Access Compliance Report

Public Rights-of-Way

(Curb Ramps)

| Intersection ID: 11389 | Main Street: E_18TH_ST | Cross Street: N_CALDWELL_ST | Location: W |

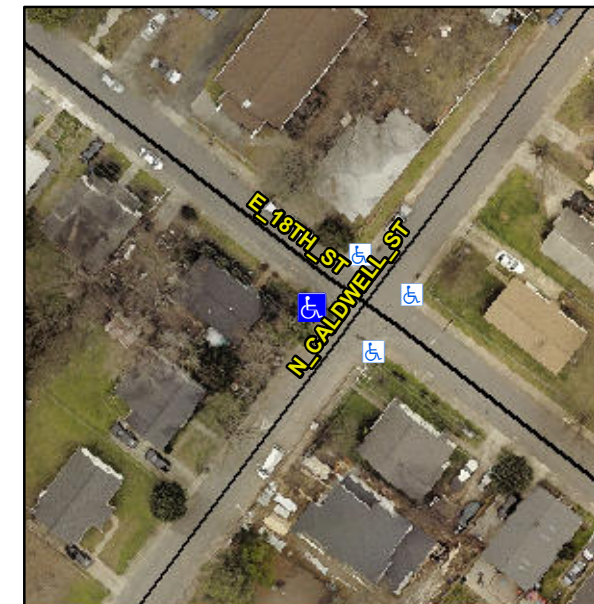
| ADA ID: 758113B609C8 | Ramp Type: PerpDiag | Initial Pass/Fail: Fail | Overall Compliance: No |

Not Found, R304.5.1, R304.2.2

| Compliance | Description | Data | Compliance | Description | Data |
|------------|-----------------------|-------|------------|-----------------------------|-------|
| N/A | Ramp Length (in) | 42.5 | No | Ramp Slope (%) | 11.4 |
| No | Ramp Width (in) | 43.0 | Yes | Ramp XSlope (%) | 0.6 |

Remove & Replace Curb Ramp With Two New Directional Ramps or Equivalent.
